BEFORE INDEPENDENT HEARING COMMISSIONERS APPOINTED BY THE  
TASMAN DISTRICT COUNCIL

Application for resource consent by  
**Māpua Community Boat Ramp Trust**

STATEMENT OF EVIDENCE OF GARY NOEL STEVENSON  
ENGINEERING

Dated: 1 November 2024

#2> boat trailer - lightning 20031125 1027 75°

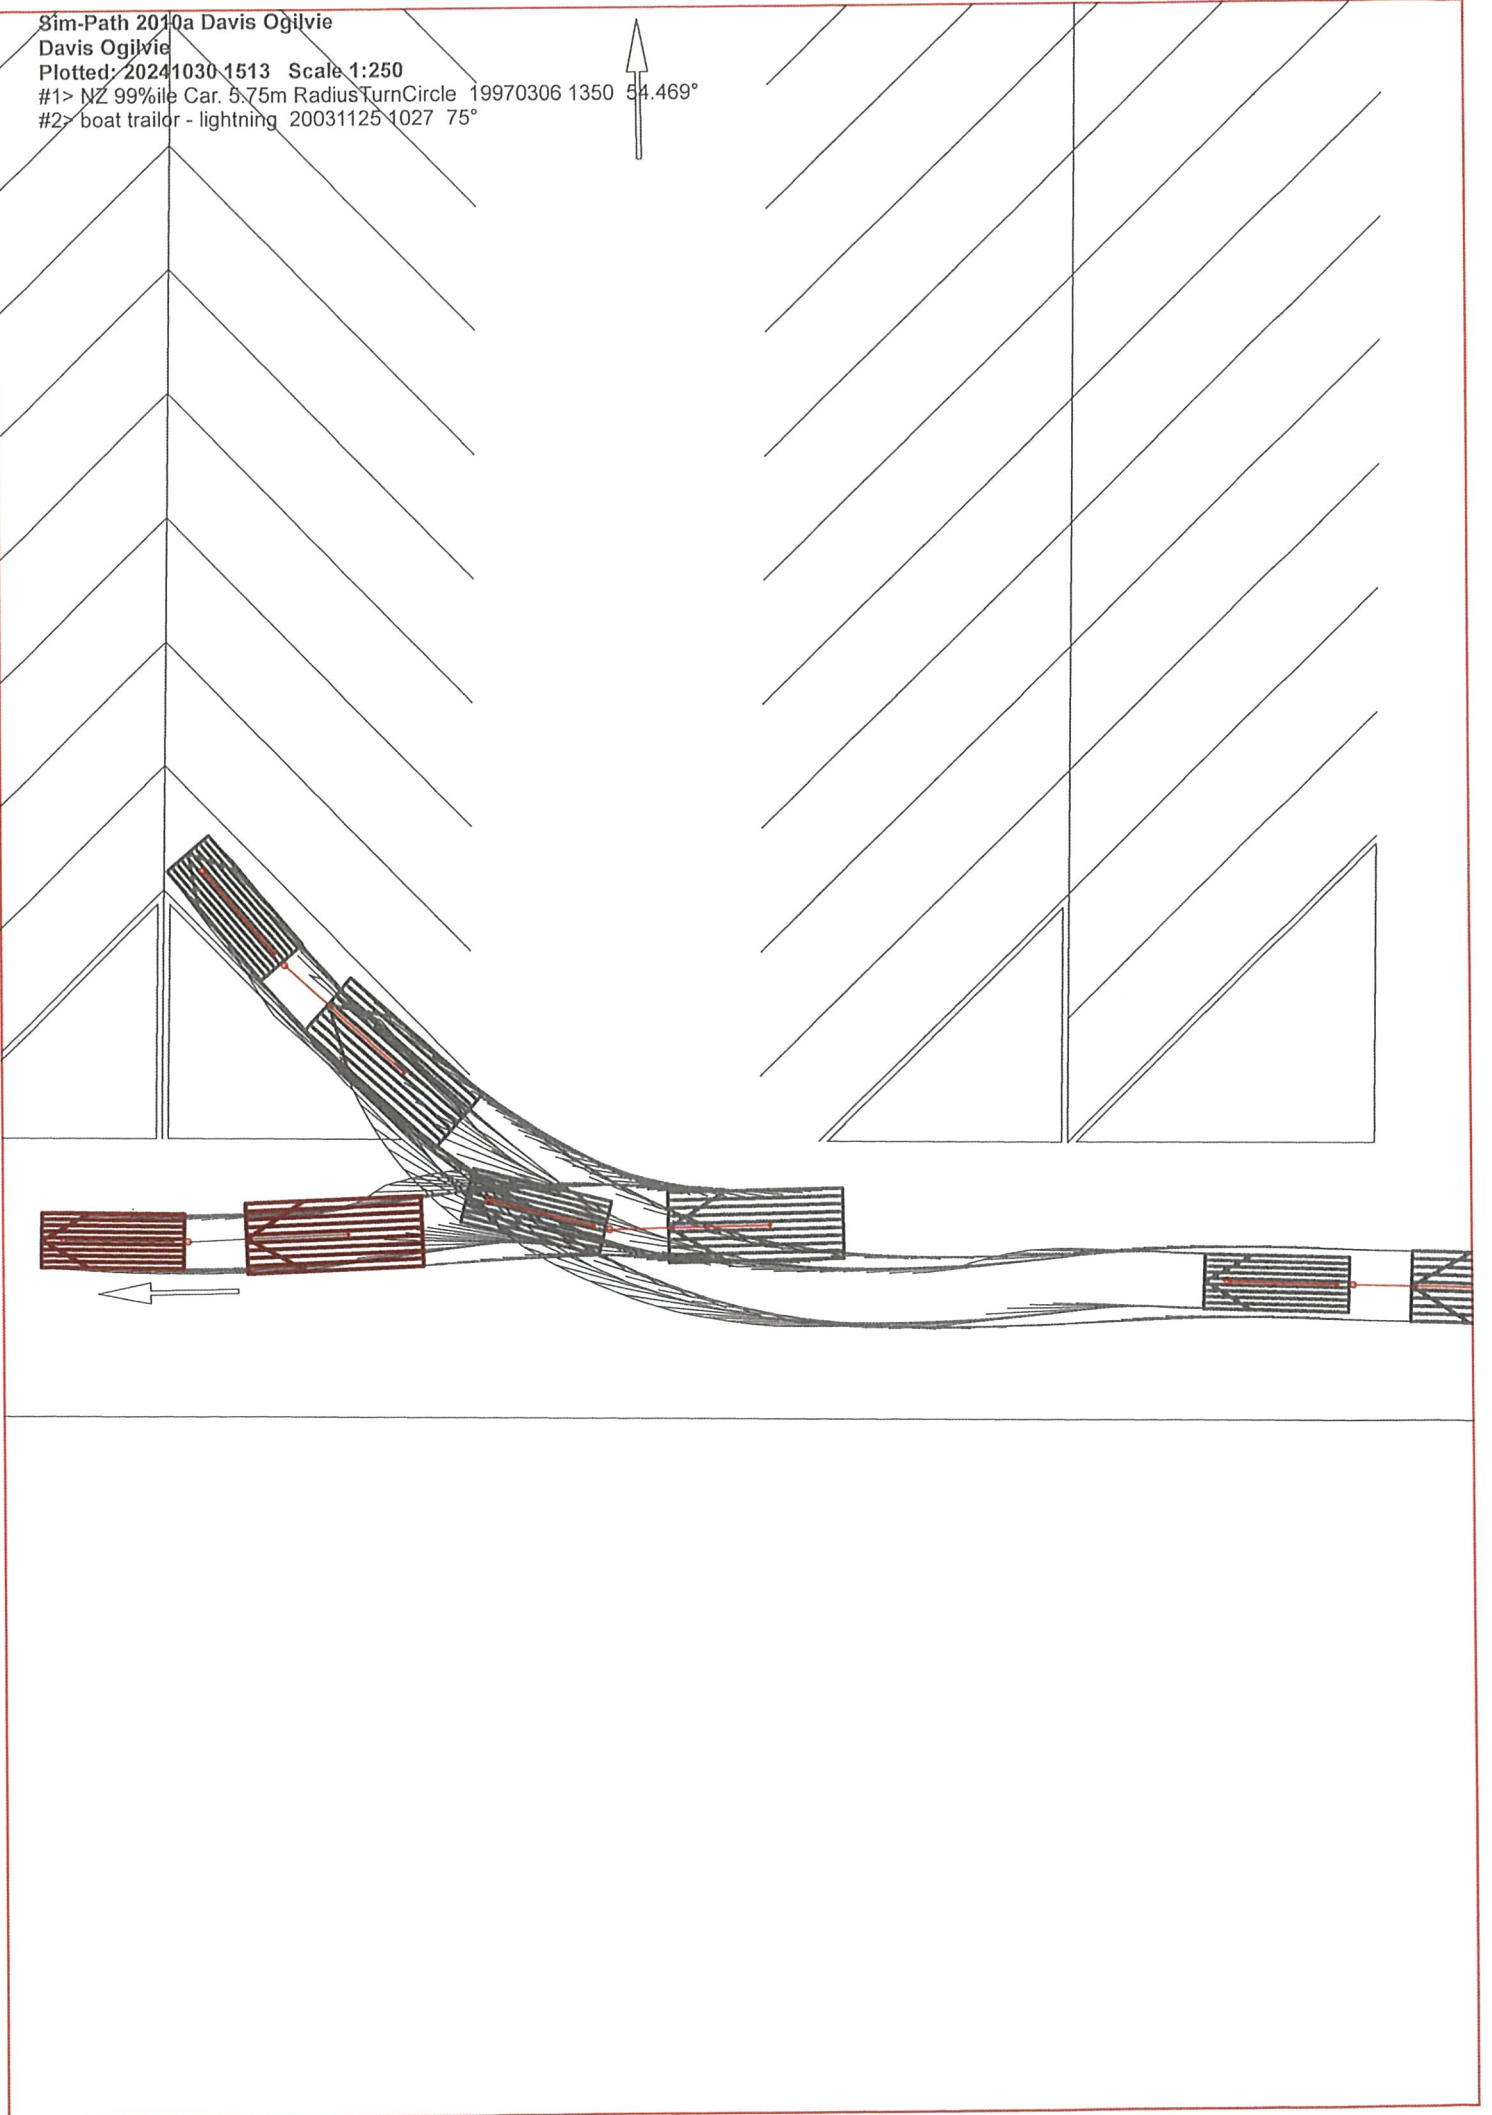
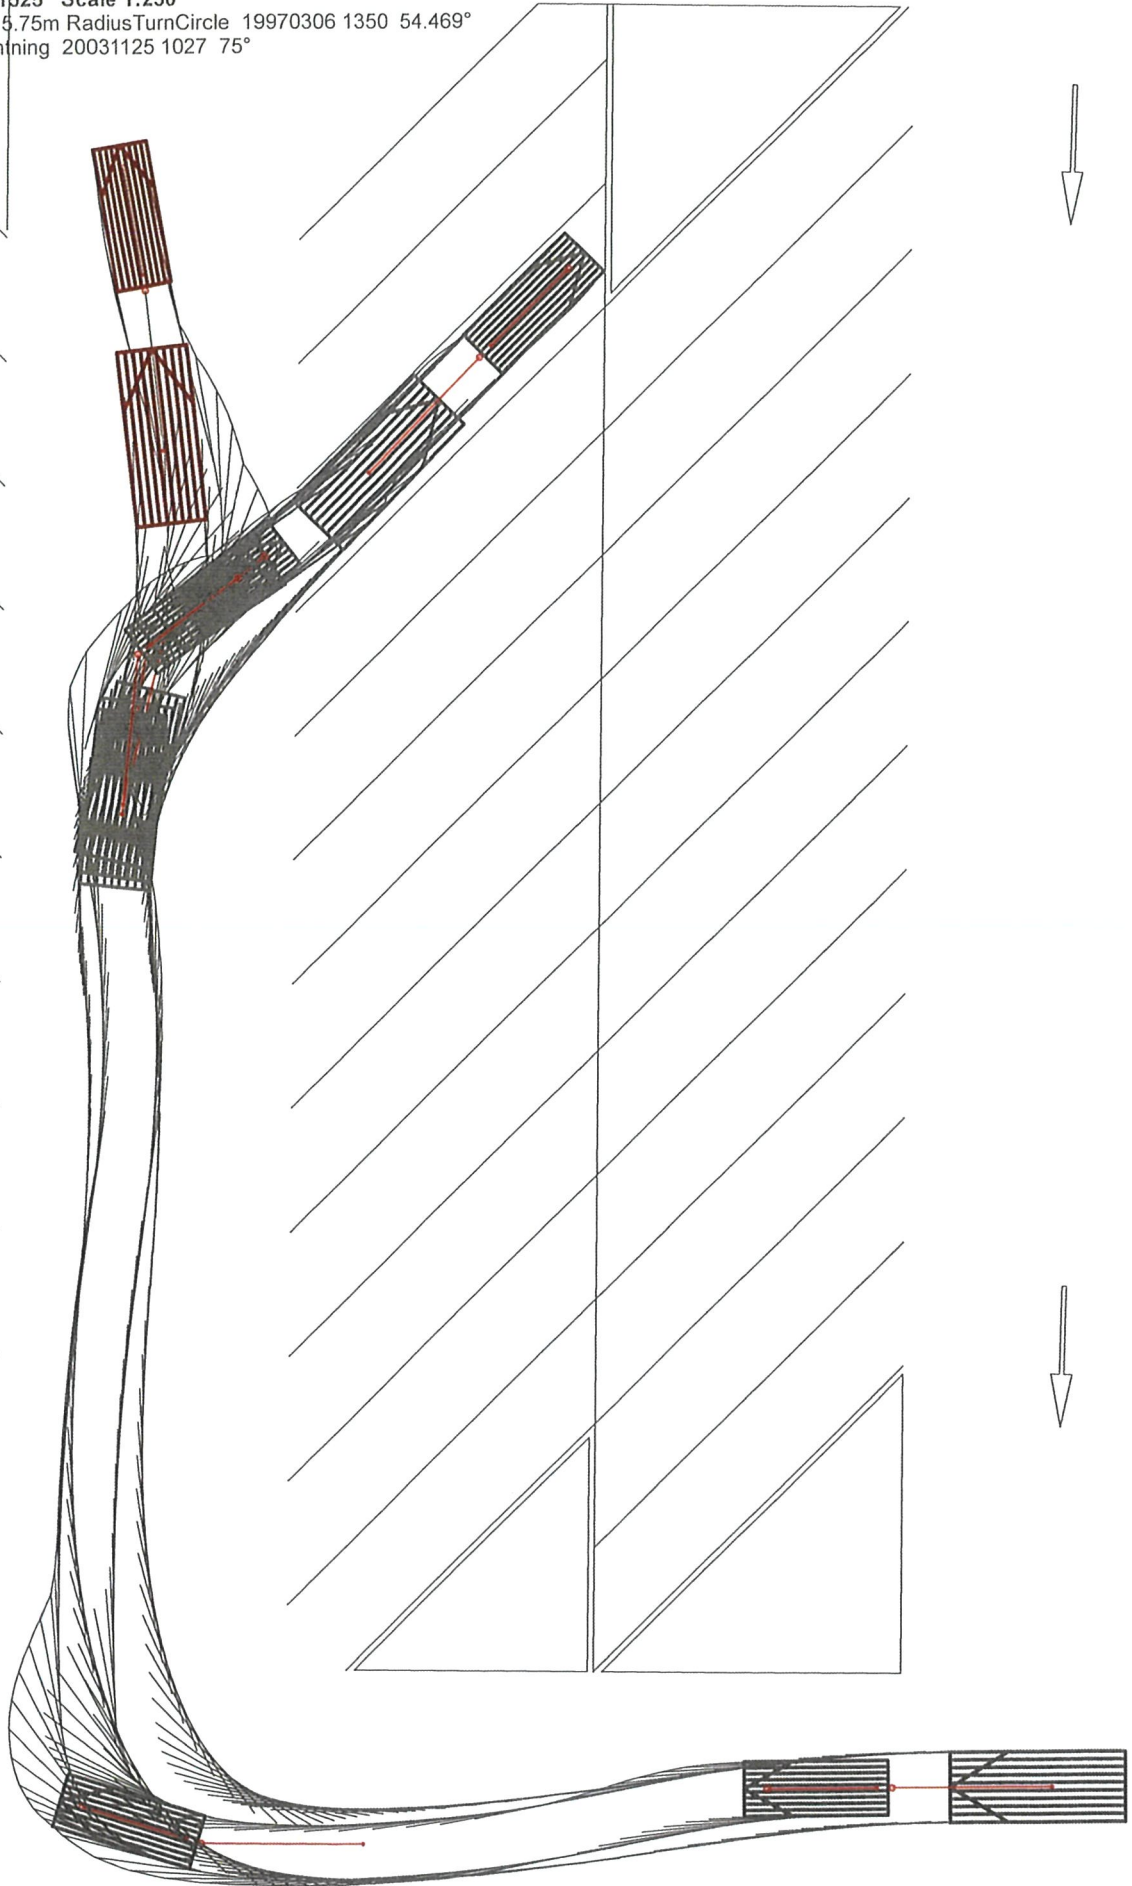
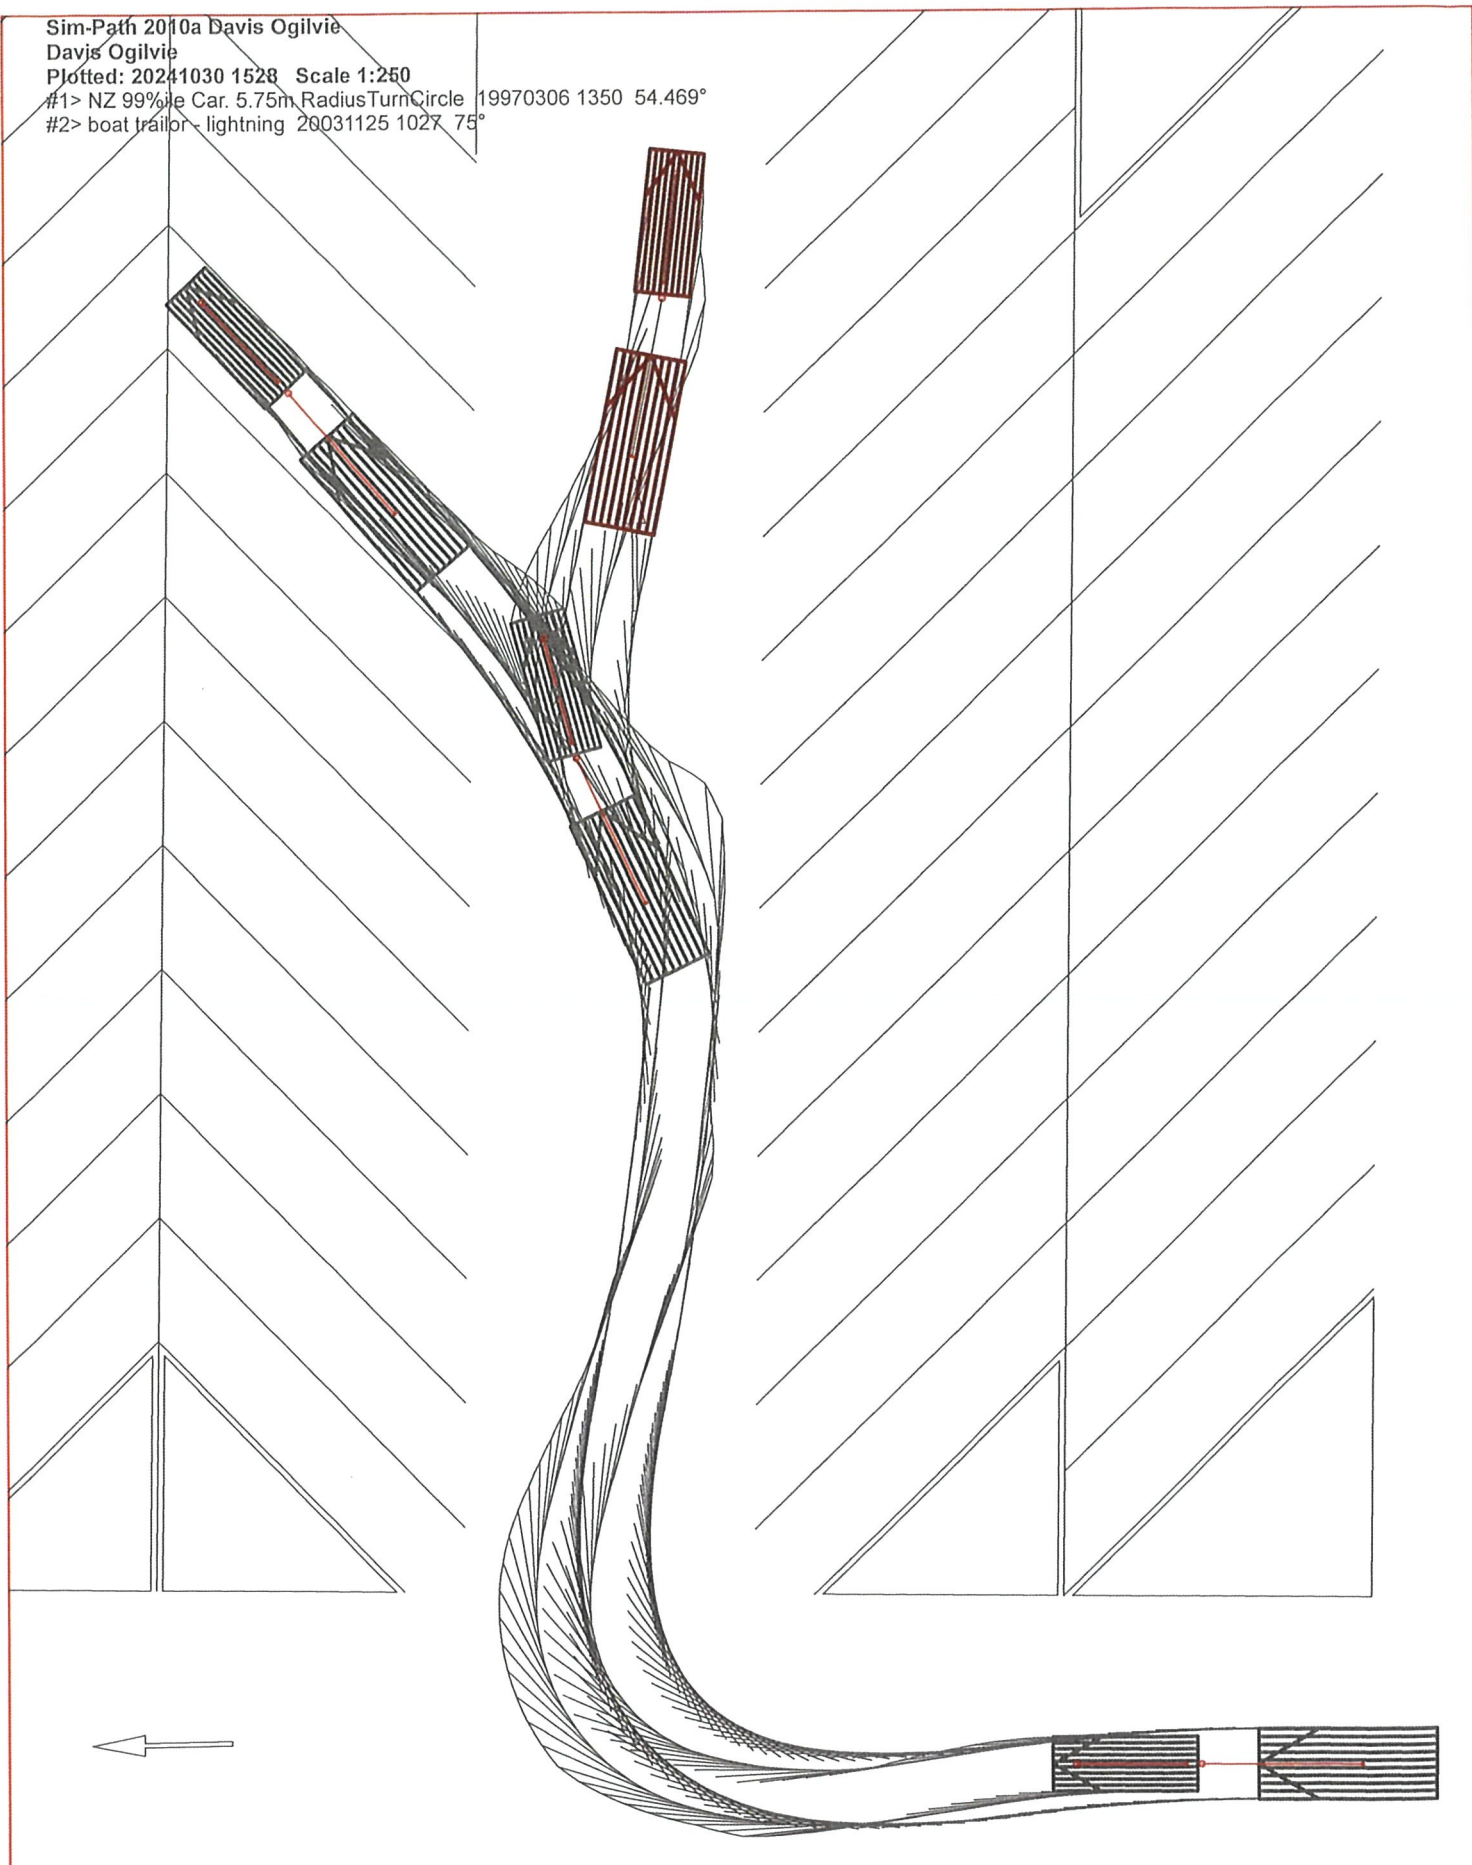
22. (S42, 14.11) Stantec raised concerns with swept paths of 10 parking spaces located in the western car park.

24. (s42, 14.23 & 14.24) Stantec have noted that tracking curves have not been provided for manoeuvring through the car park from the accessway barrier arm and on the ramp.

I comment: Annexed is a swept path analysis drawing that shows these parks can be utilised. I note that the parking is also provided for overflow parking and can be utilised for this purpose.

I comment: I annex tracking curves to show that this is achievable.
